Salisbury Historic District Commission
AGENDA

Salisbury Historic District Commission

Salisbury Historic District Commission

Case Number:	#26-26
Commission Considering:	Window Replacement
Owner Name:	James Weaver & Elizabeth Scheid
Owners Address:	6701 Jerome Ave Springfield, VA 22150
Applicant Name:	David Scheid
Applicant's Address:	200 E William Street
Agent/Contractor:	NA
Subject Property Address:	313 Gay Street Salisbury, MD 21801
Historic District:	Newtown Historic District
Use Category:	Residential
Zoning Classification:	R-5, Residential
Structure / Site Description:	
Built Date:	1870
Enclosed Area:	1,724 sq. ft. (SDAT Real Property Database)
Lot Size:	4,543 sq. ft. (SDAT Real Property Database)
Number of Stories:	2
Contributing Structure:	NA
Wicomico County Historic Survey on file:	No
Nearby Properties on County Survey:	Yes

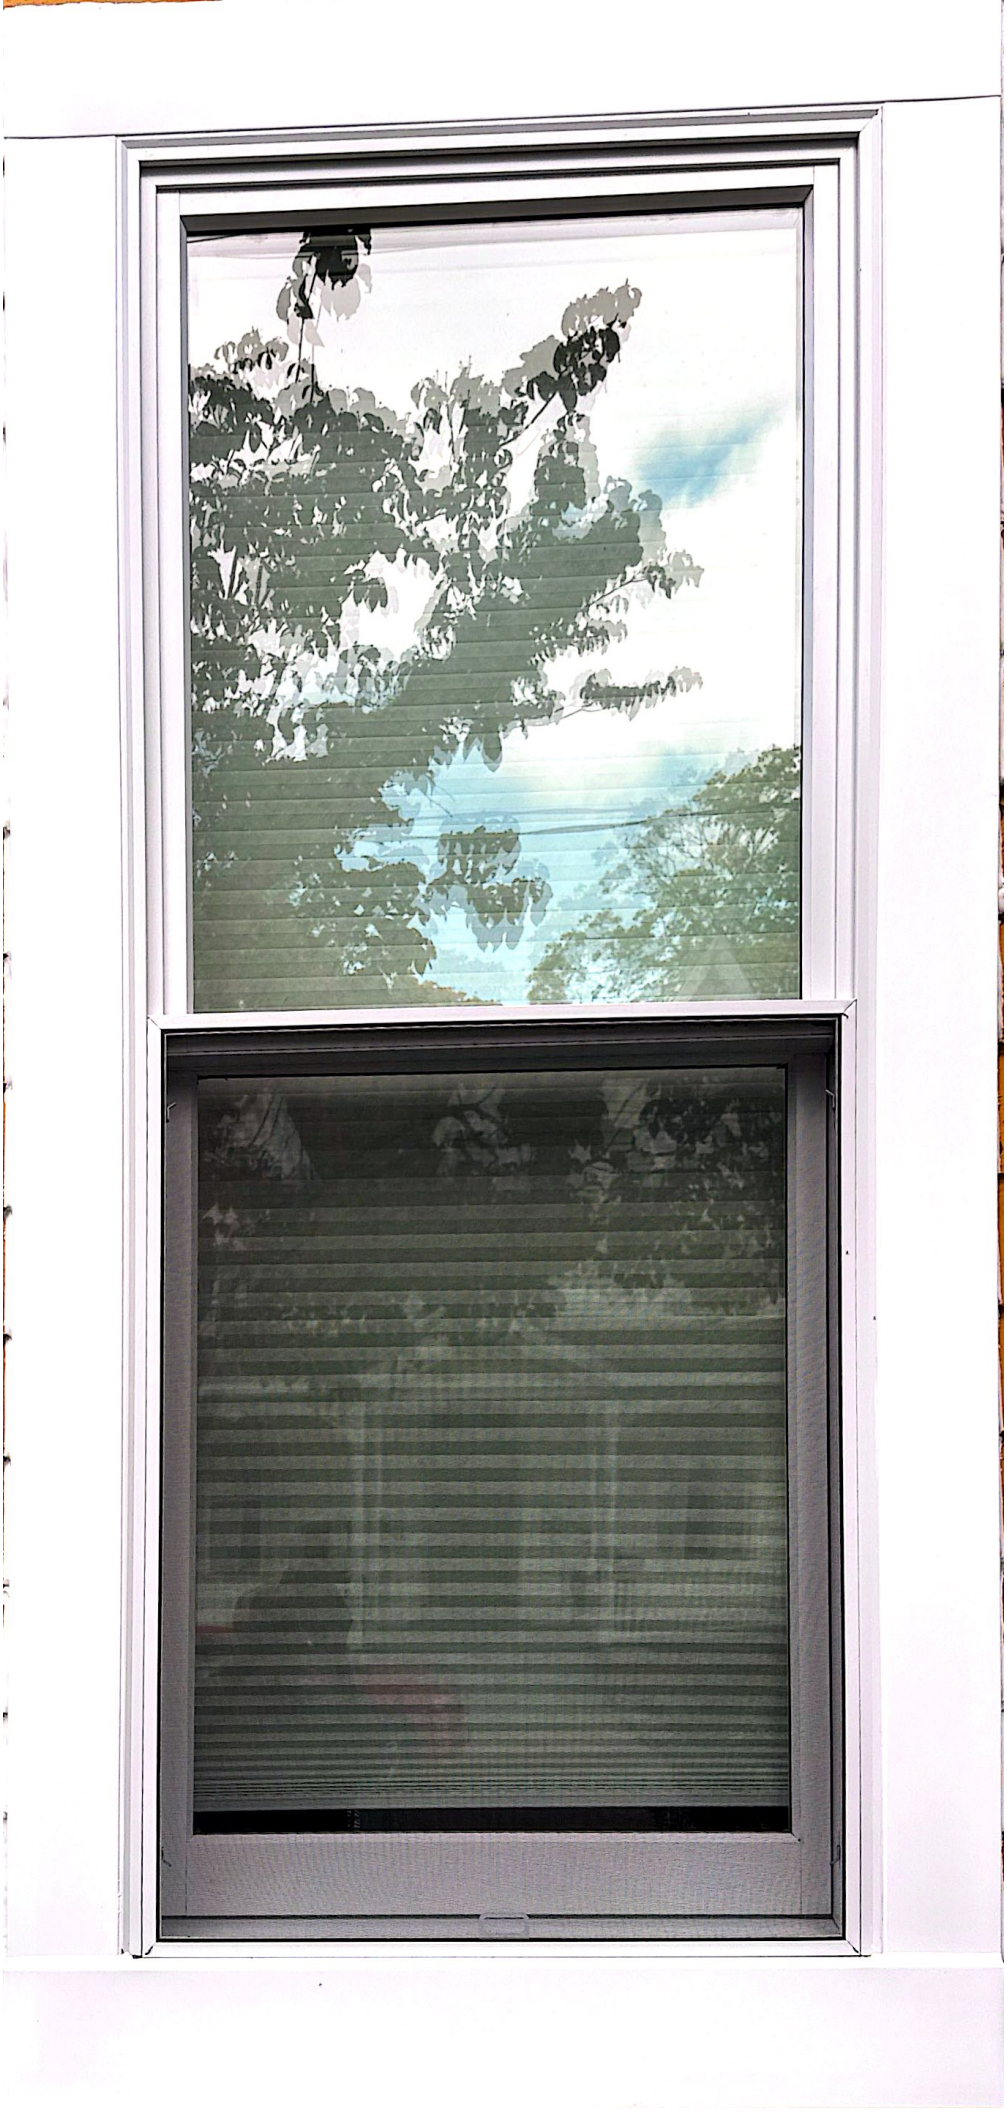
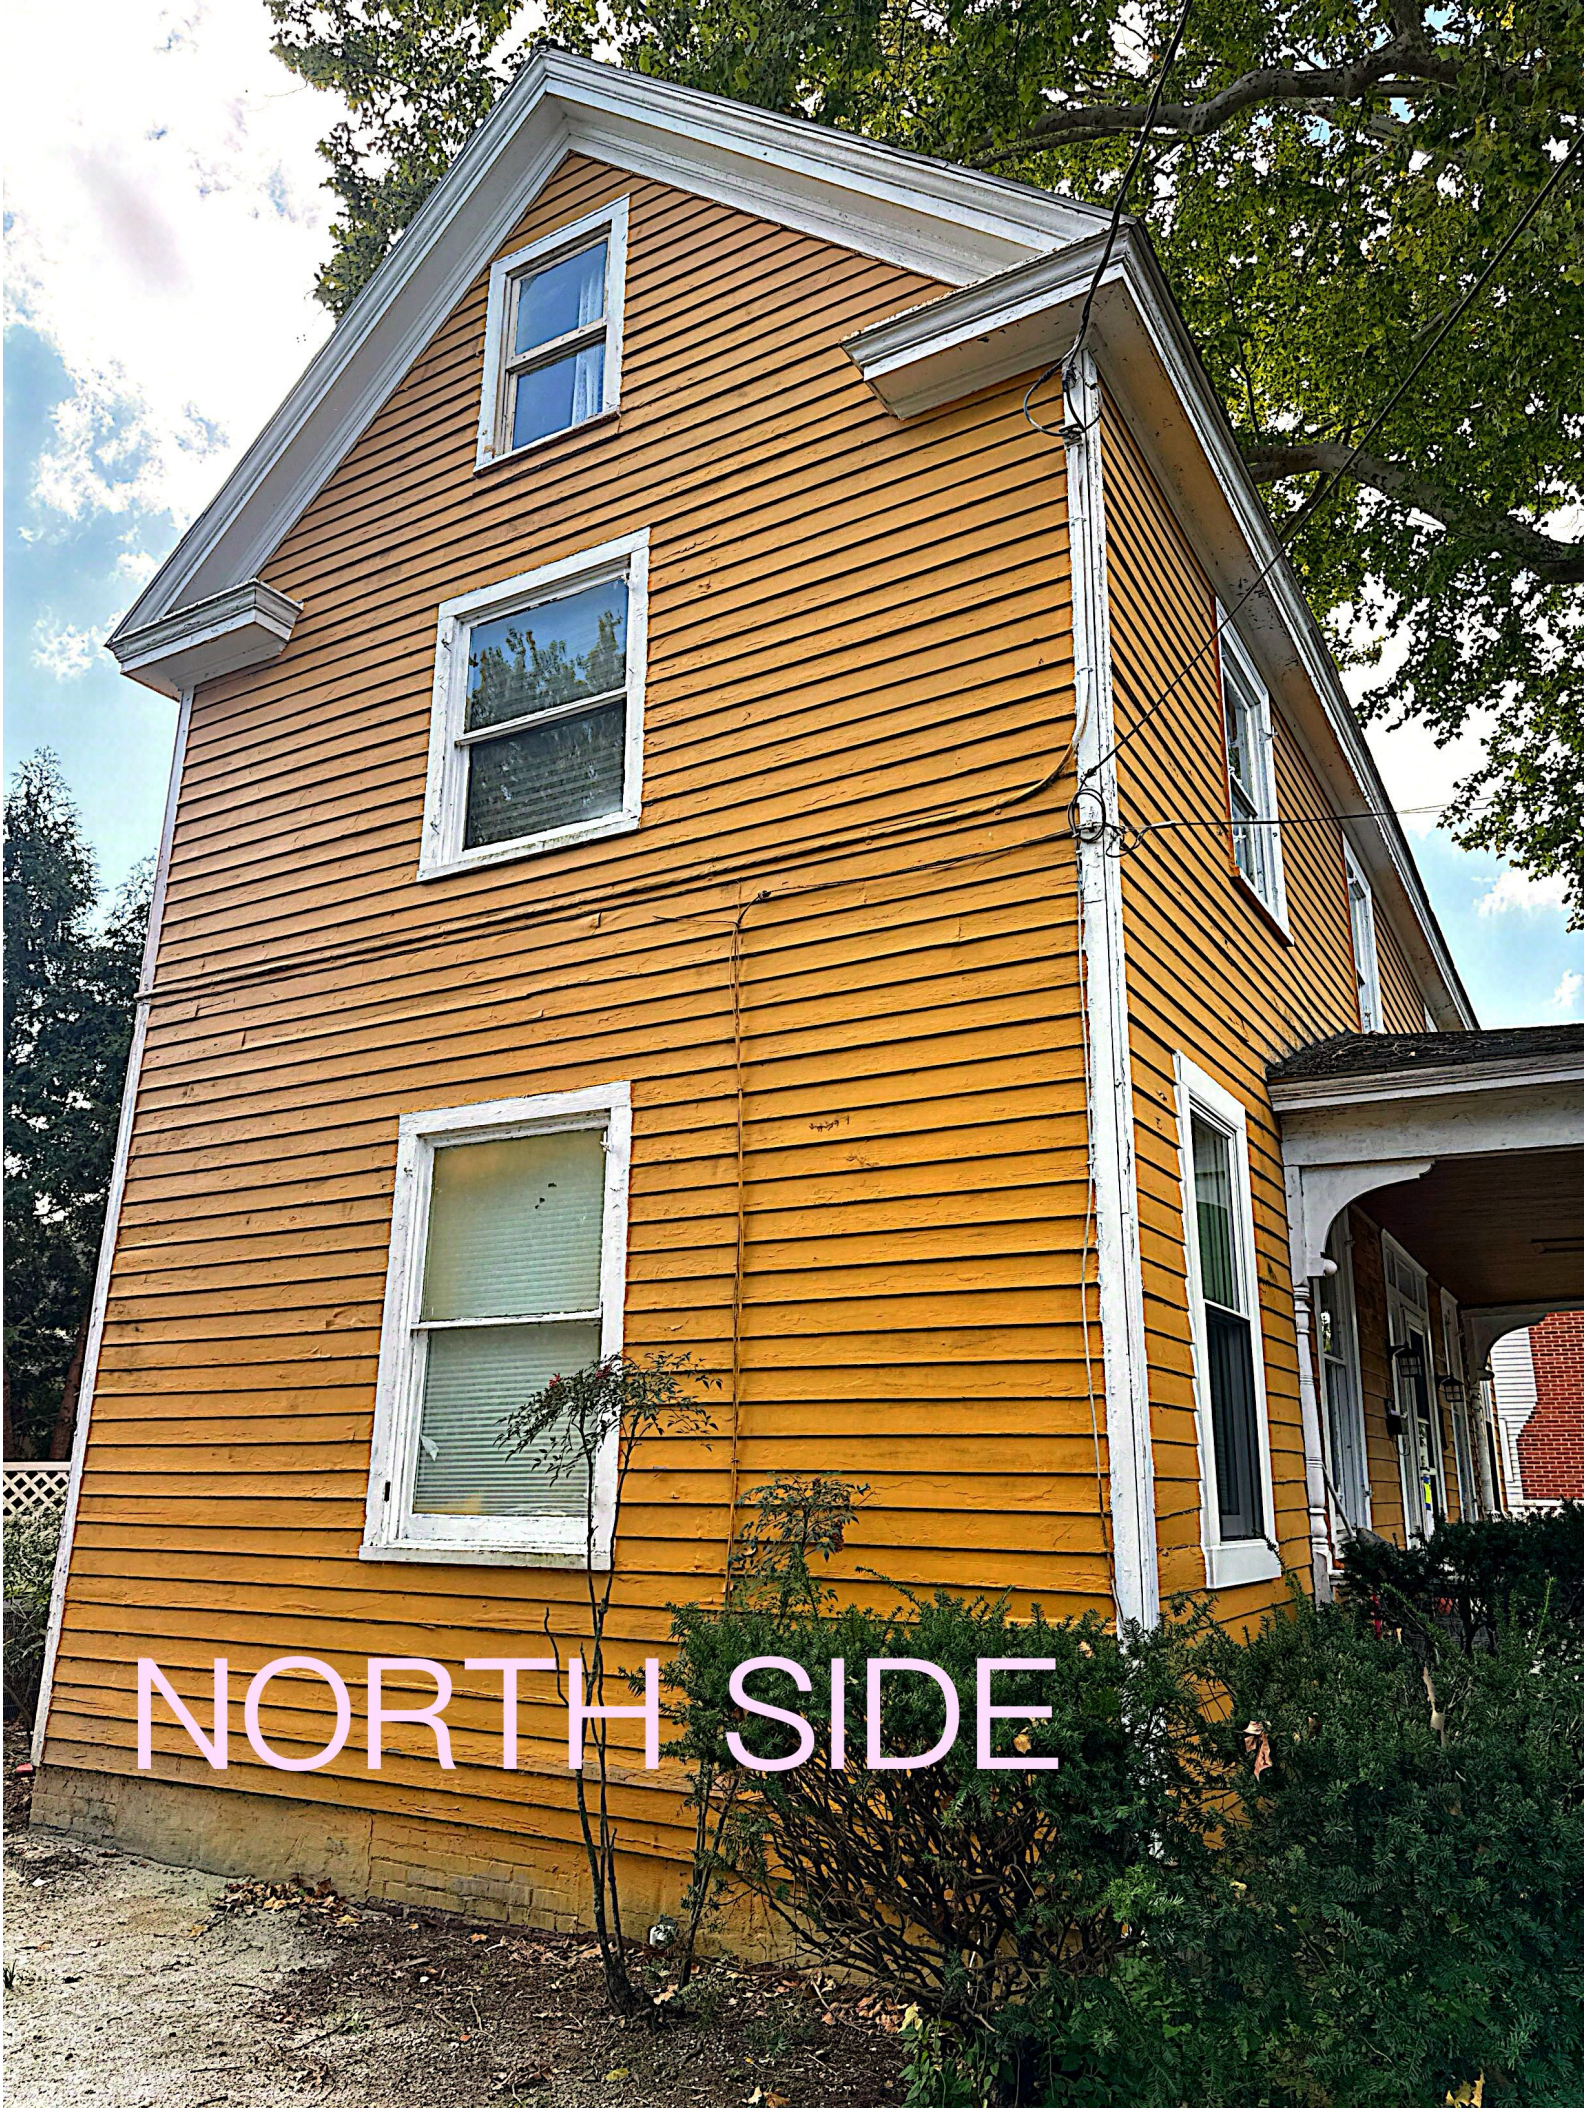
The windows that have been installed are made from enduraclud which is a natural wood interior with a protective metal exterior layer. According to Guideline 51 new windows should match the historic window in size, type, glazing and profile. The new windows have an entirely different casing than the original windows, offering a more modern aesthetic to the structure. The staff recommends denial as the windows do not match the existing wood windows in style, material or profile.
